RE: Construction Permit Application No. 2489 – Wild Rice River Structure

CONSTRUCTION PERMIT NO. 2489

SUBJECT: **Construction Permit Application No. 2489 - Wild Rice Control Structure
2nd Permit Review Phase for "Fargo Metro Area Risk Reduction Project"**

Figure 1. Proposed modifications to the Project since the 2013 Supplemental Environmental Assessment.

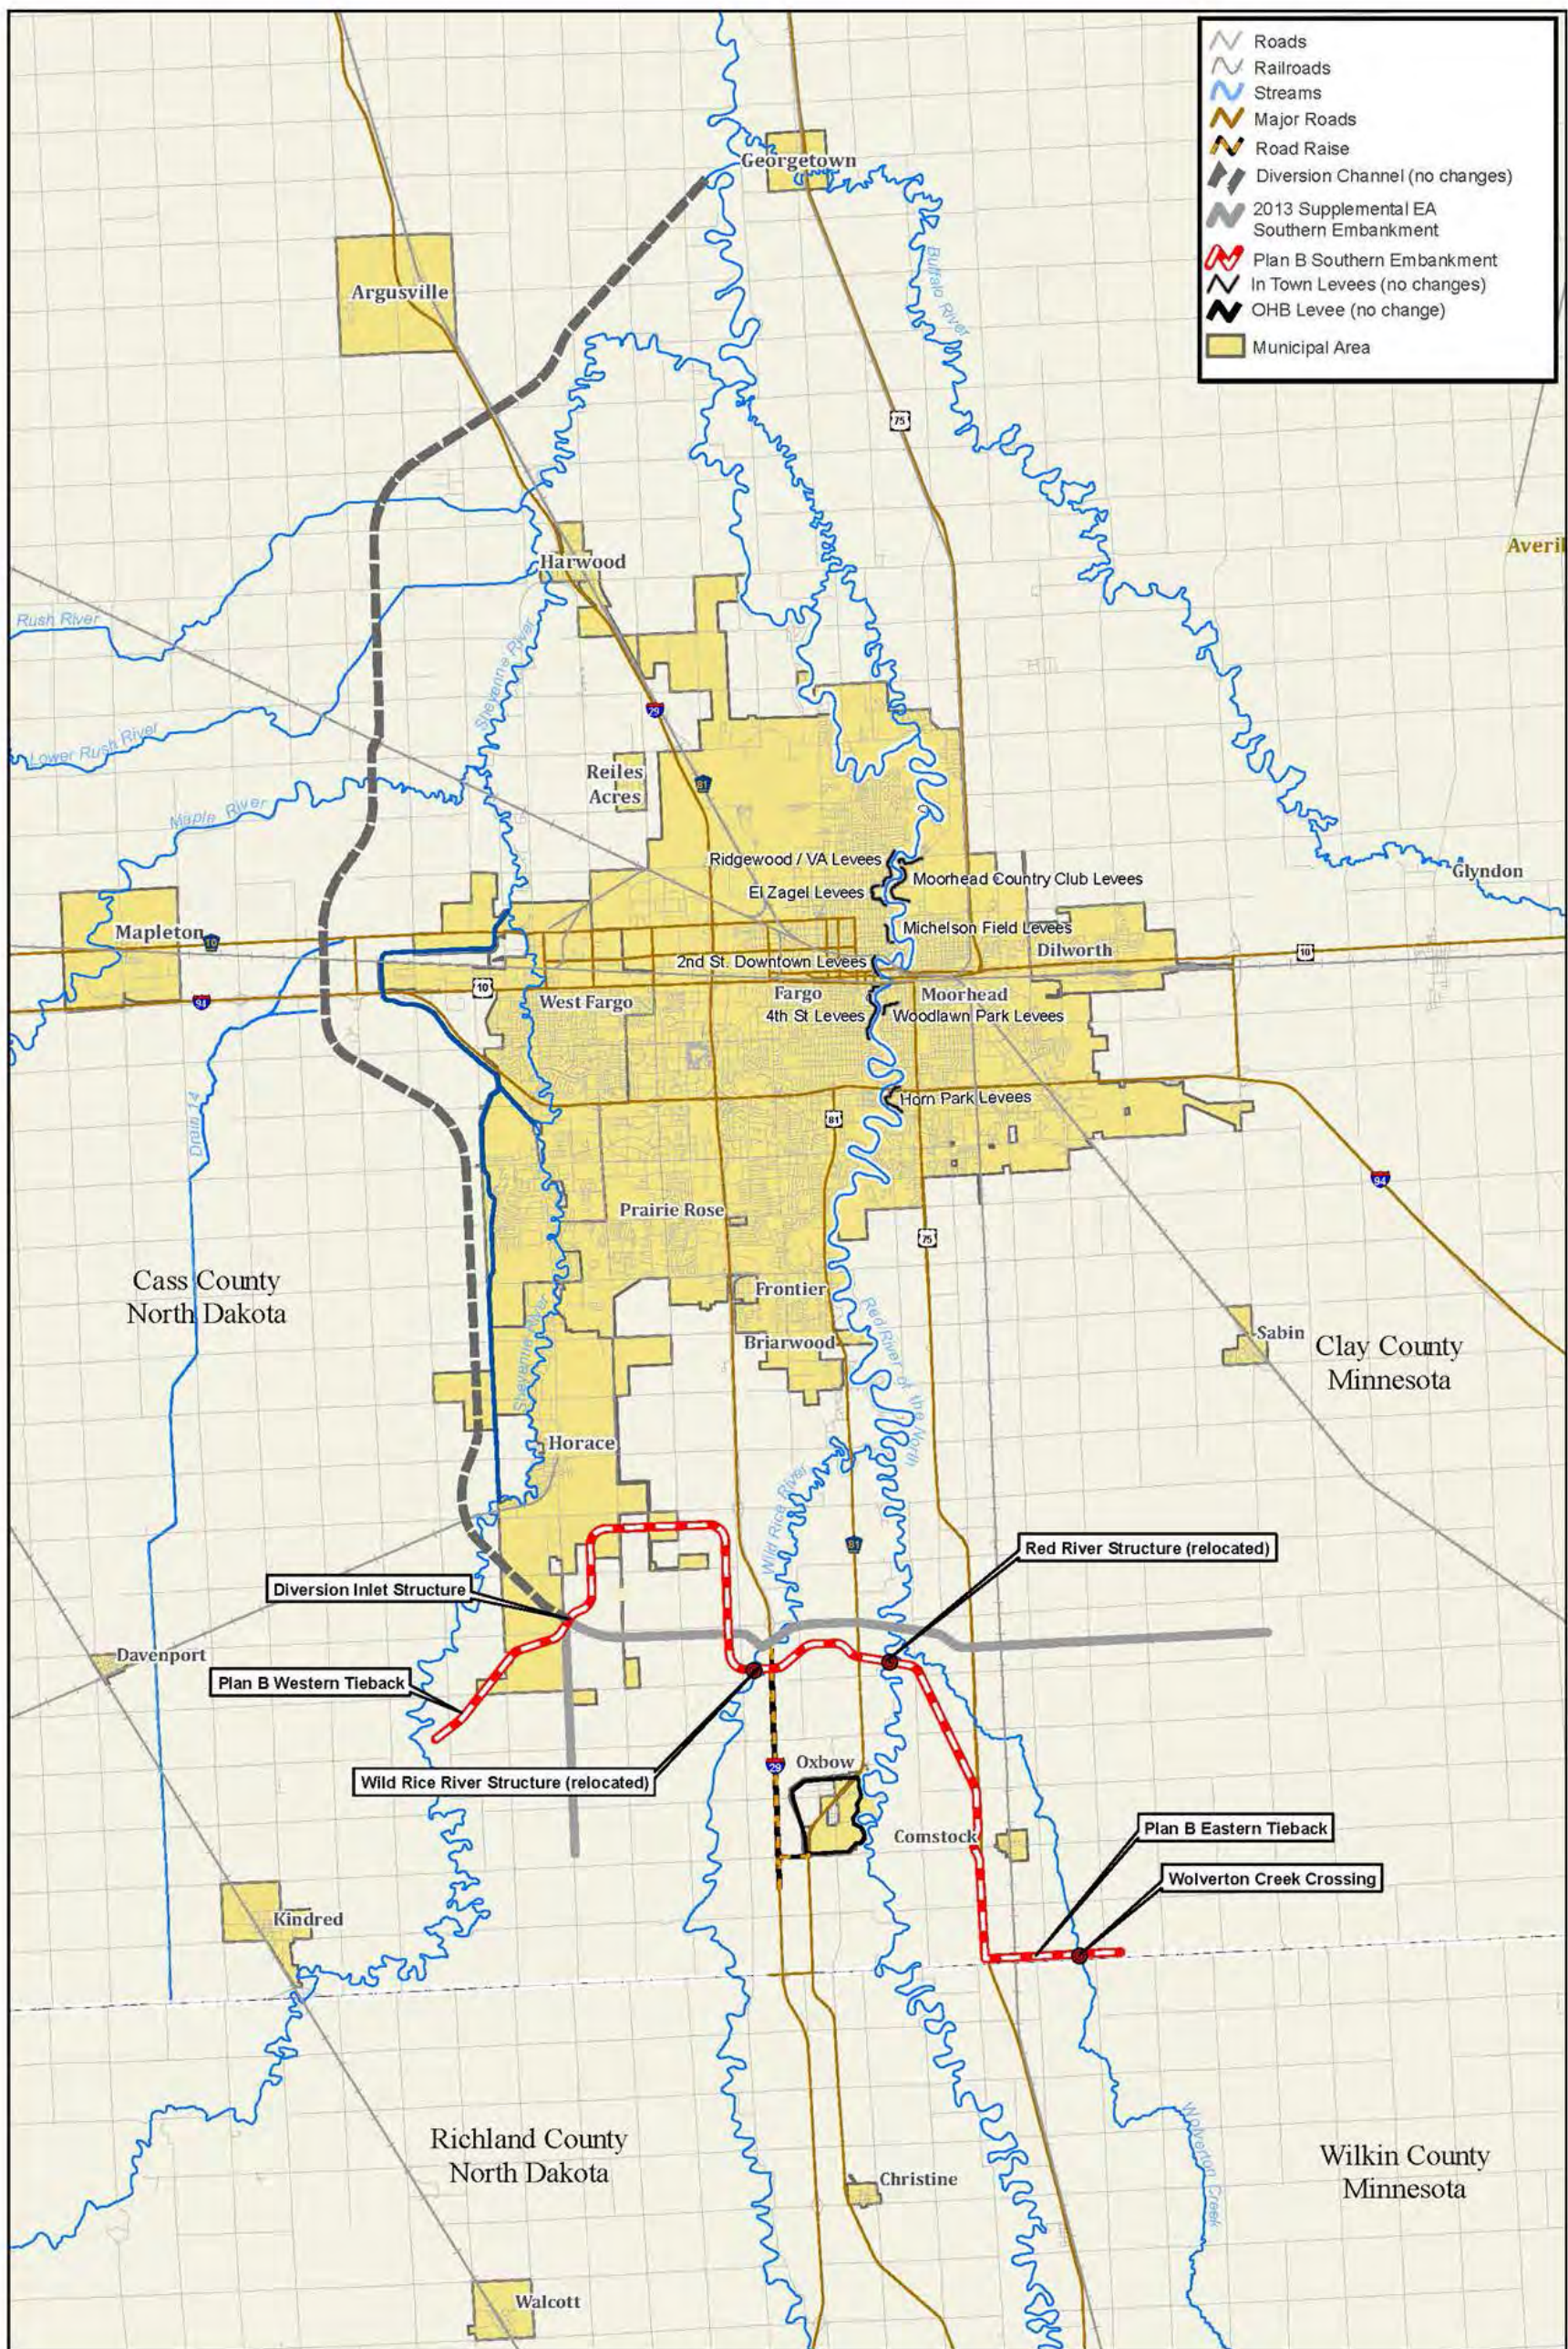
Several substantial Project changes materialized from the Governors' Task Force and TAG work. These changes are well documented in the Corps' EA No. 2 and the application materials, but generally, the Project changes can be summarized in several areas, which are listed below:

- 2) The western end of the Project alignment, considered the "Western Tieback," was moved west and north to accommodate additional storage necessary in North Dakota to meet Governor's Task Force criteria.

- 3) The middle of the Project alignment, considered the "Southern Embankment," was moved north to accommodate additional storage necessary to meet mitigation concerns raised in the Governor's Task Force. This includes relocation of the Red River and Wild Rice River Structures.

- 4) The eastern end of the Project alignment in Minnesota, considered the "Eastern Tieback," was moved south and east along the western side of Wolverton Creek in Minnesota to balance effects of the Project in Minnesota as discussed in the Governor's Task Force. A structure will be constructed in the Eastern Tieback to accommodate Wolverton Creek flows through the embankment.
